Addendum to the  
Environmental Impact  
Assessment Report

**NISA**  
*North Irish Sea Array*

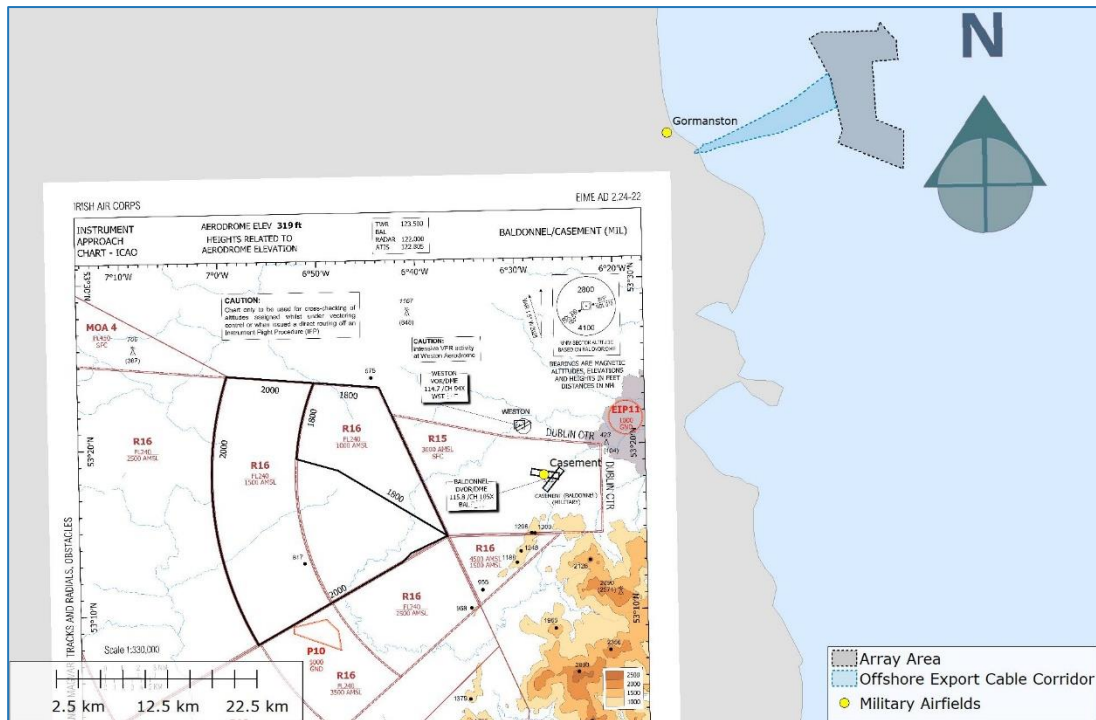
In response to Section 17 (b) of the RFI, where the applicant is requested to confirm through consultation with AirNav and daa that the layout and reduced height applied to a number of turbines for the Project Option 2 layout is satisfactory, the following Section 4 details the radar line of sight modelling of the new Tooman radar that was requested through the consultation process. This section shall be added to Appendix 19.1 of the 2024 EIAR following Section 3.

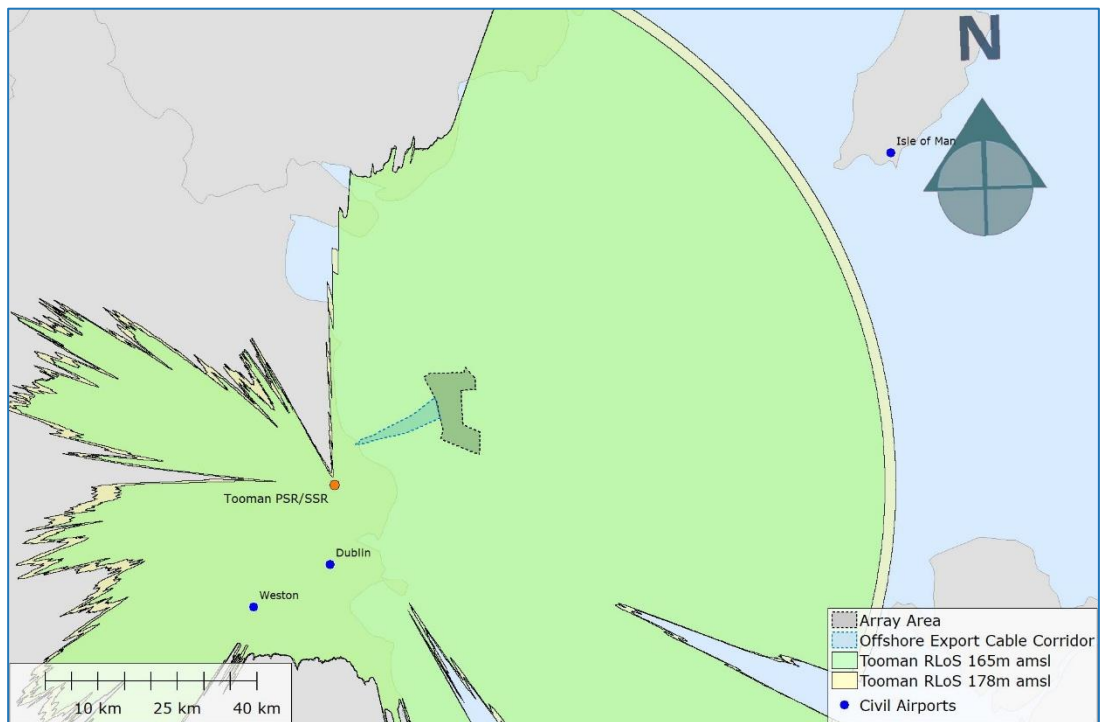
In response to Section 17 (b) of the RFI, where the applicant is requested to confirm through consultation with AirNav and daa that the layout and reduced height applied to a number of turbines for the Project Option 2 layout is satisfactory, the following Section 5 details the modelling of the new Tooman Secondary Surveillance Radar facility that was requested through the consultation process. This section shall be added to Appendix 19.1 of the 2024 EIAR.
